# TOWARD A CONNECTED MONTLAKE LID

An urban design review of Seattle's SR-520 Replacement project

Using drawings from WSDOT's 2012 Community Design Process, this document highlights failures and opportunities to connect the Montlake Lid with neighborhoods, parks, light rail and UW.

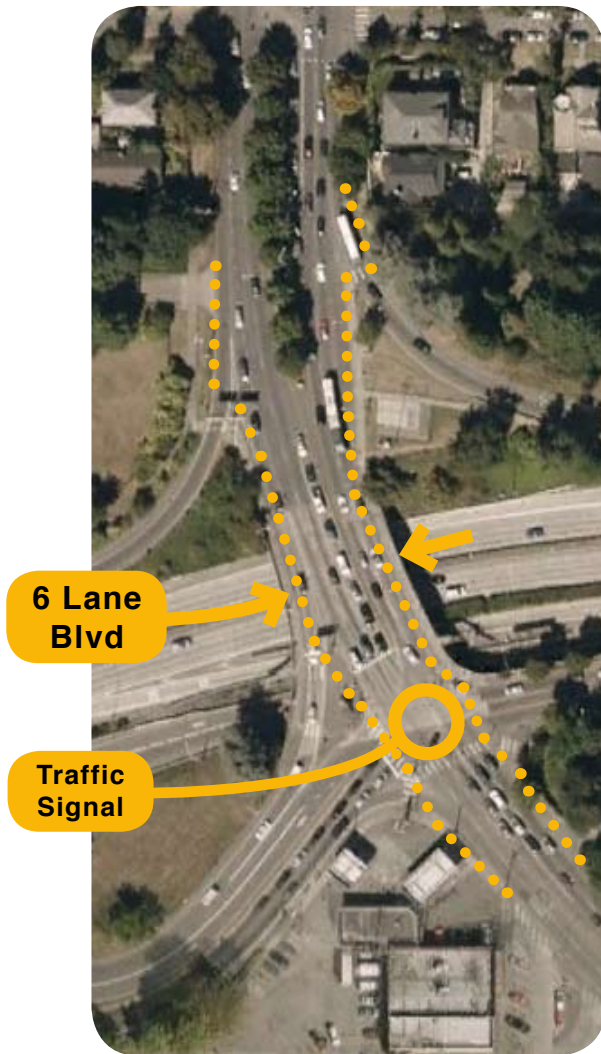
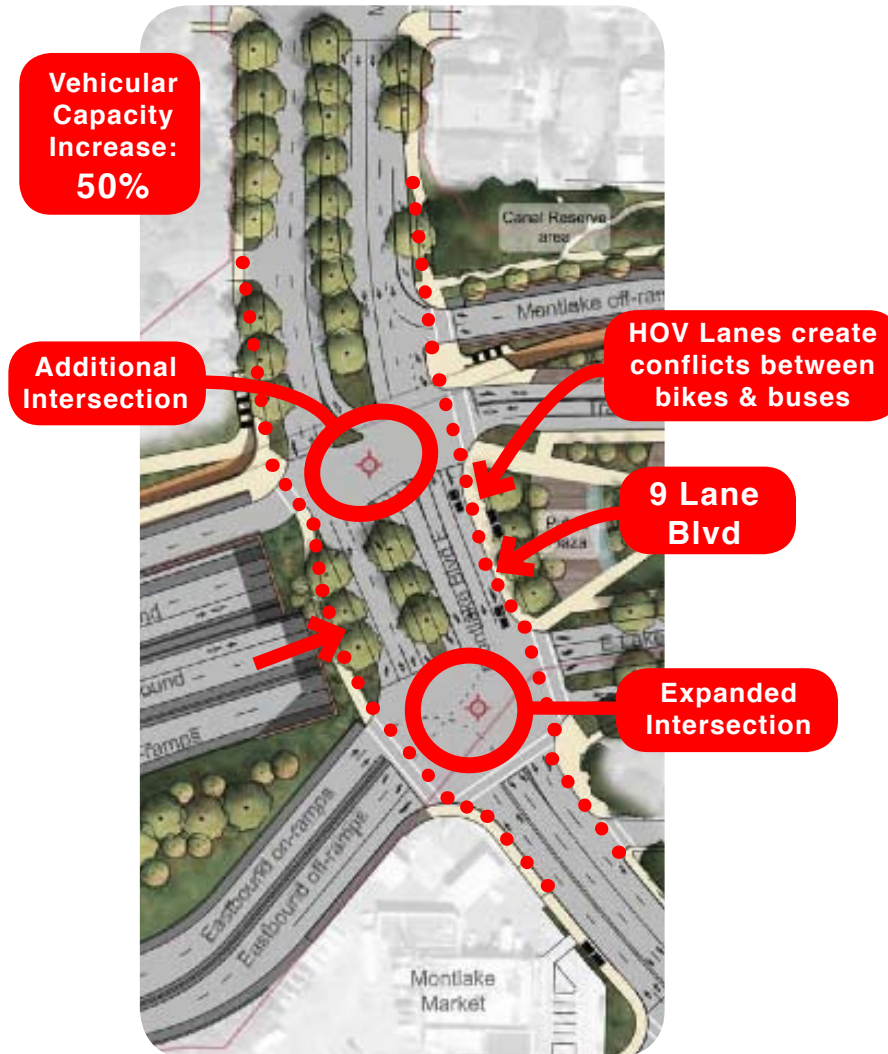
The pedestrian environment of Montlake Blvd is already poor.

Bigger intersections, more lanes to cross & increased traffic will make walking even more difficult.

Mixing pedestrians & bicycles on sidewalks creates conflicts.

Larger intersections create more conflicts for bicycles in traffic.

HOV Lanes create conflicts between bikes & buses

Encourage walking by providing safe, direct & traffic-separated routes

Consider cycle tracks or other traffic-separated routes for bicycles

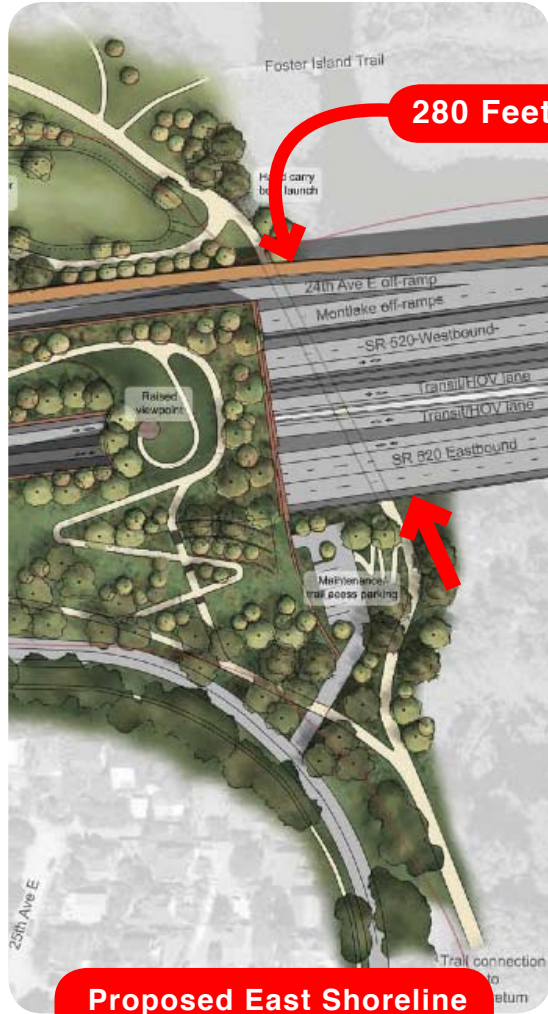
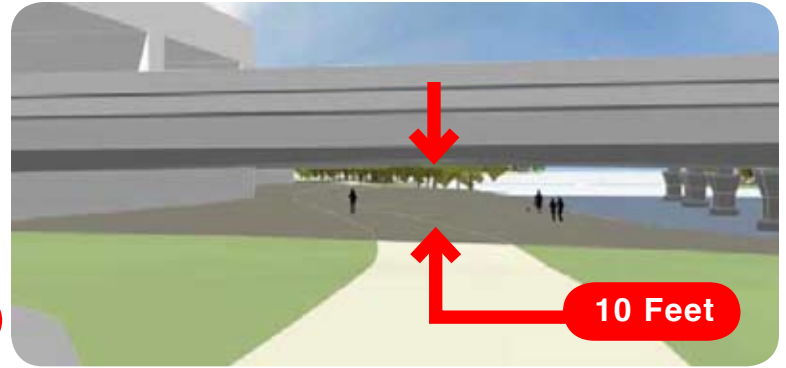
**Underbridge areas are low, dark & potentially dangerous**

**Use lids to make safe, direct and above-bridge trail connections**

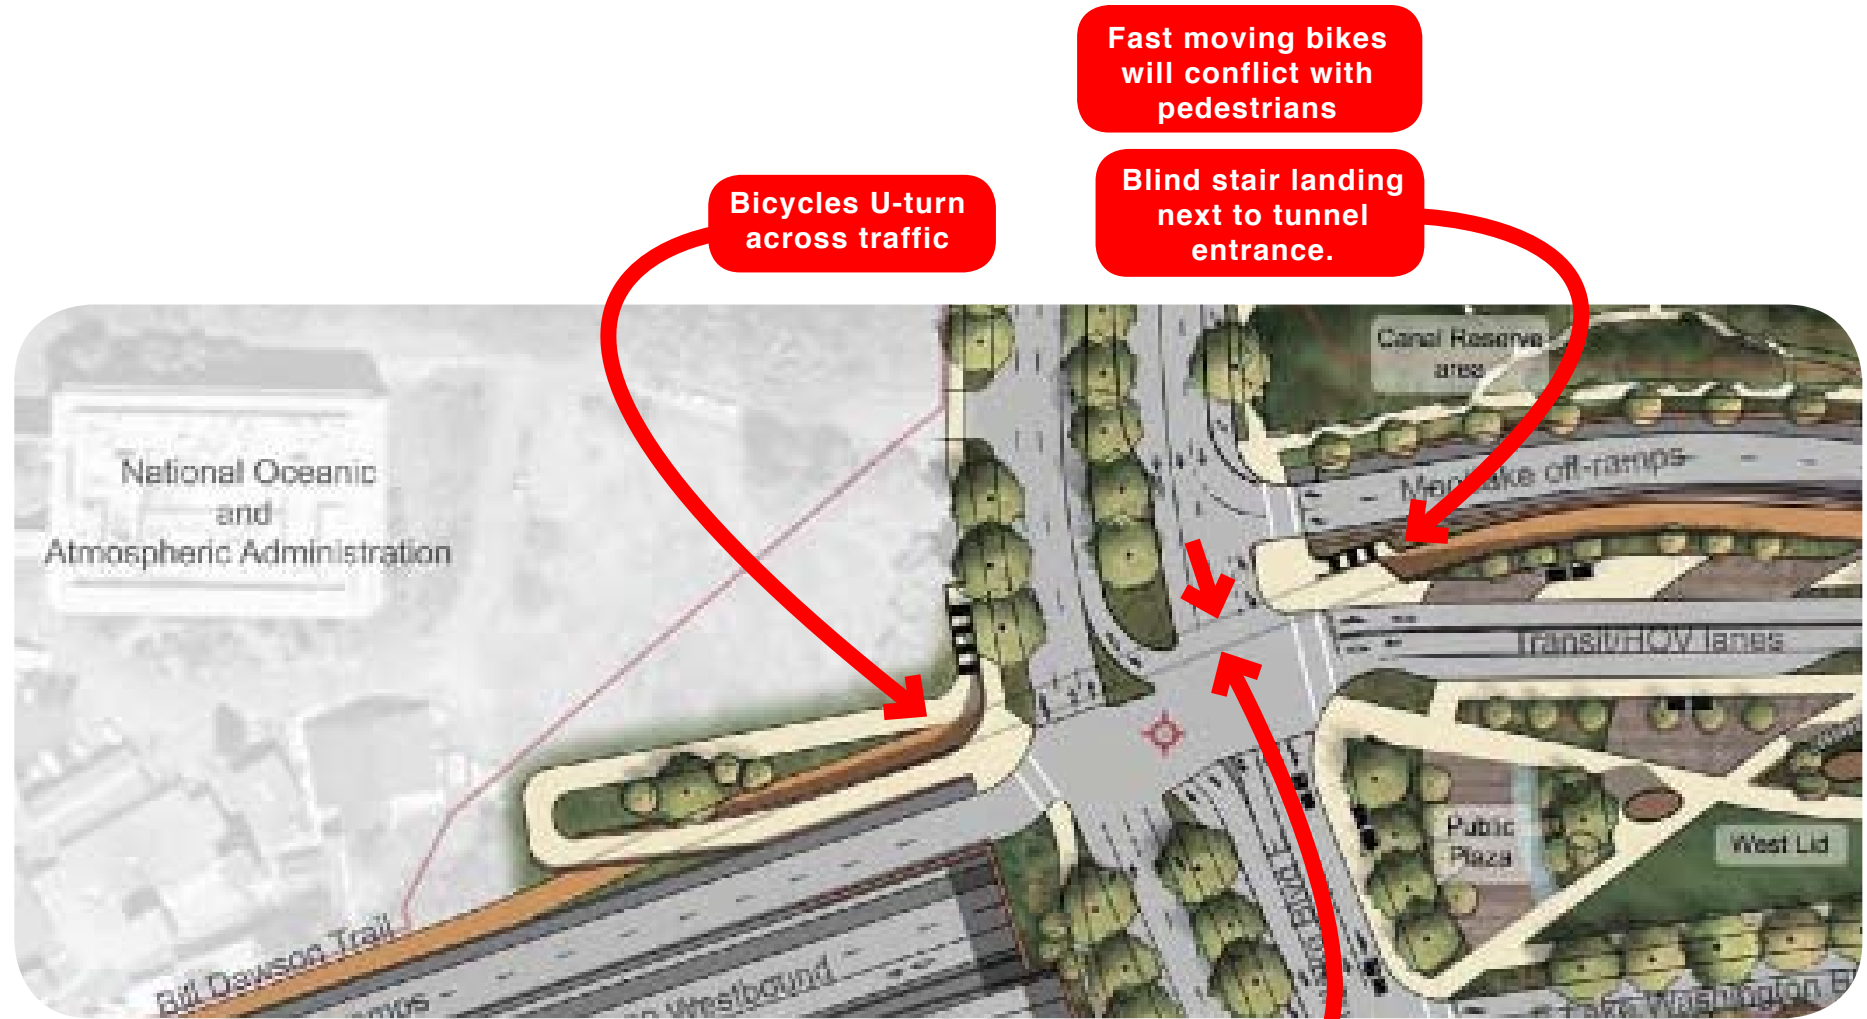
**Bicycles U-turn across traffic**

**Fast moving bikes will conflict with pedestrians**

**Blind stair landing next to tunnel entrance.**

**Narrow tunnel will feel unsafe after dark.**

**Poor connection:  
Pedestrians and  
bicyclists must  
cross ramp traffic.**

**Widen tunnel to create separate paths for bikes & pedestrians.**

**Consider overpass option to increase safety**

**Connect lid to  
stormwater park  
(see next page).**

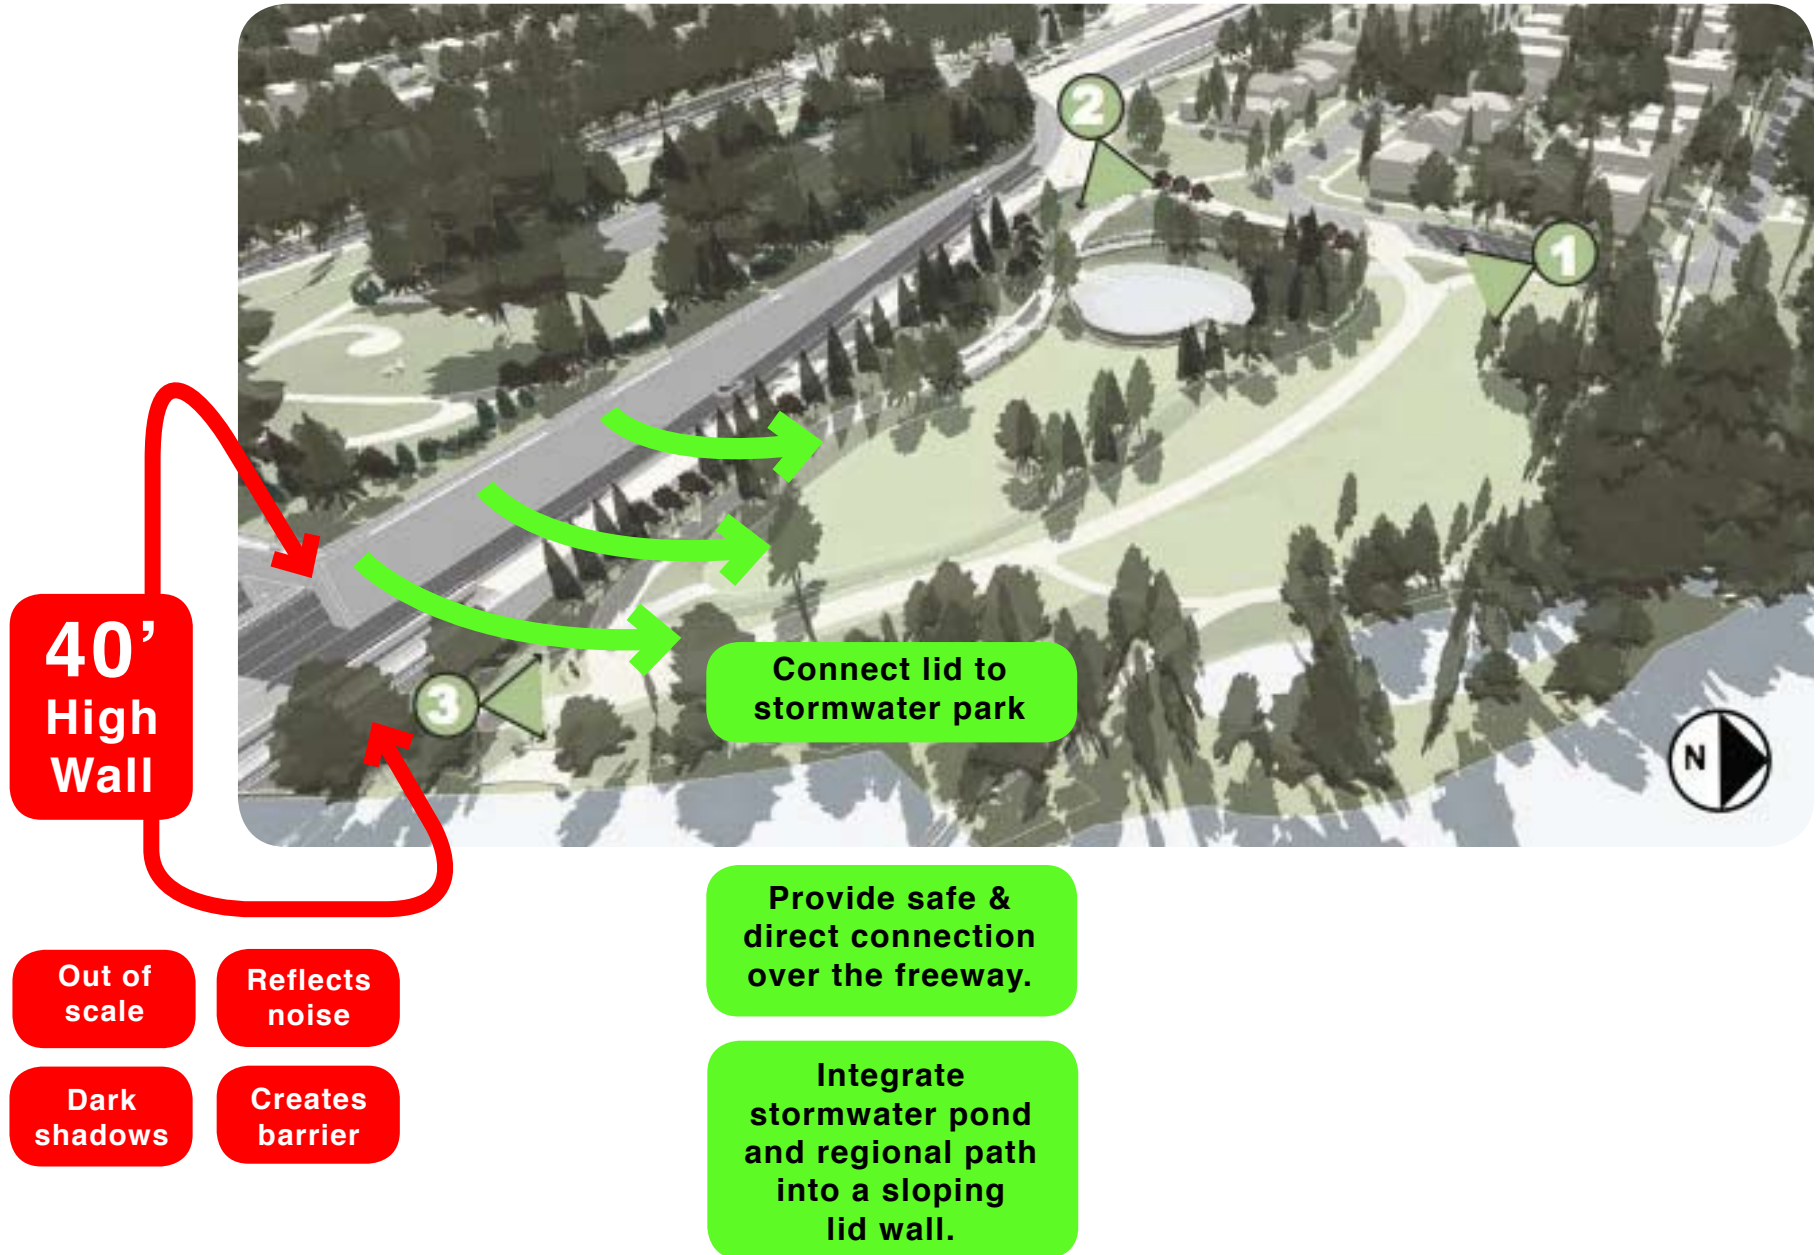
**Traffic lanes discourage  
access to park space.**

**Open space will feel  
isolated and unsafe.**

**Consider ways to  
naturally ventilate tunnel  
& remove O&M facility.**

**Create multiple  
smaller lids  
for better  
connectivity.**

# -- 8 -- CONNECT WITH NEIGHBORHOOD GREENWAYS FOR SAFE & DIRECT PASSAGE OVER 520

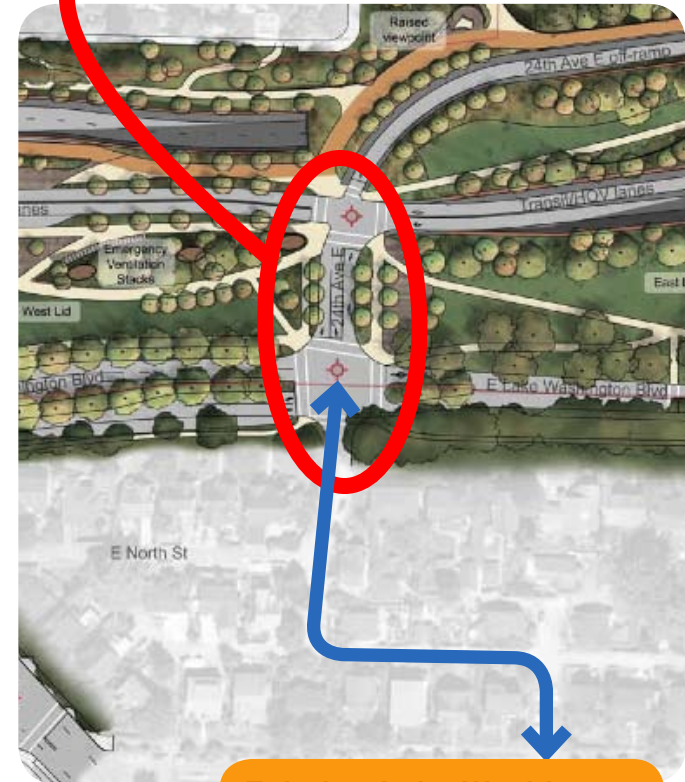
Greenway ends without...

... a safe, direct and traffic separated path over 520.

Existing bicycle route to become freeway access road.

Coordination with community Neighborhood Greenways groups and Seattle bicycle and pedestrian masterplanning to ensure good connections to and from project area

# -- 10 -- CONNECT PORTAGE BAY BRIDGE TRAIL TO MONTLAKE BLVD

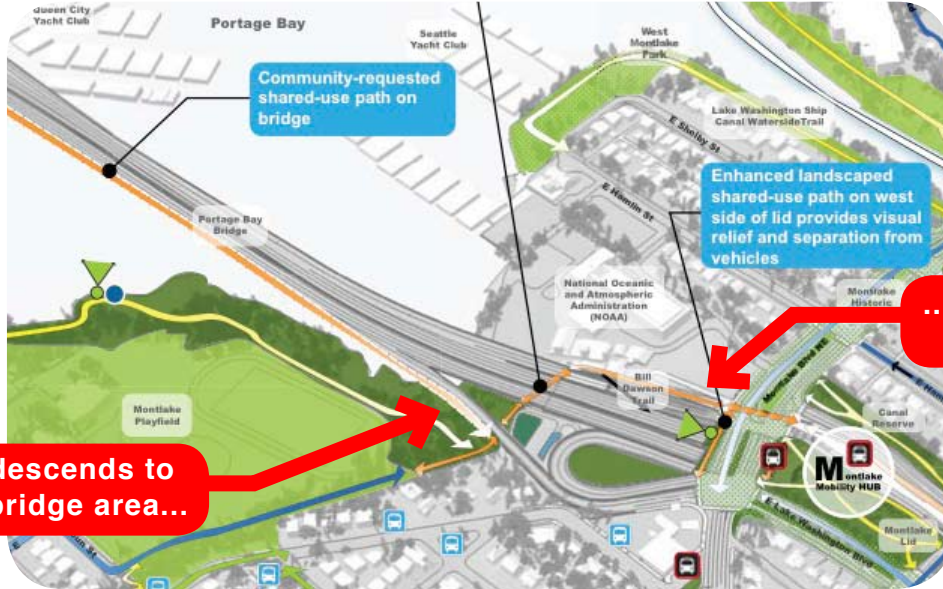
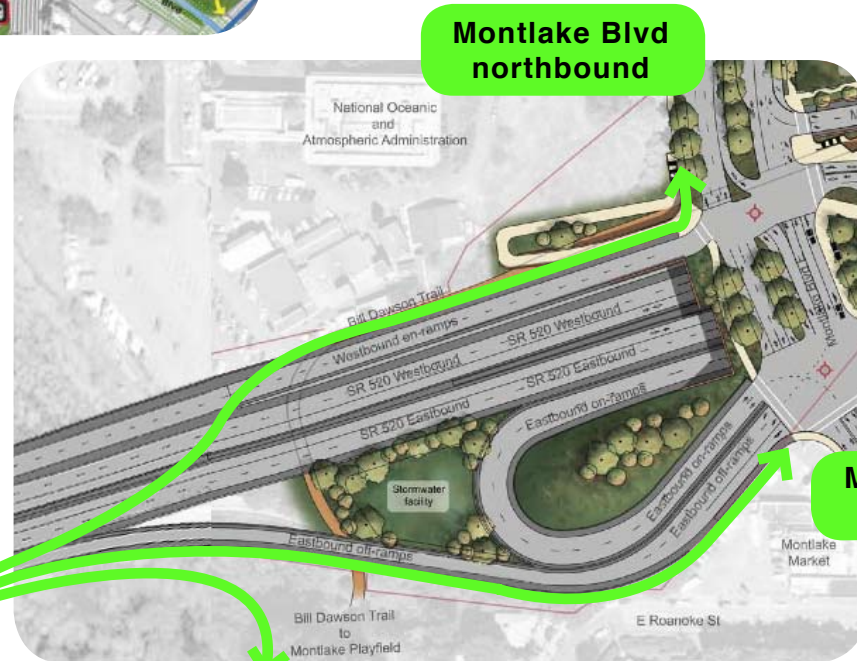
Trail descends to underbridge area...

...with arduous climb up to Montlake Blvd.

Connect Portage Bay Bridge Trail to...

...Montlake Playfield ...Local Streets
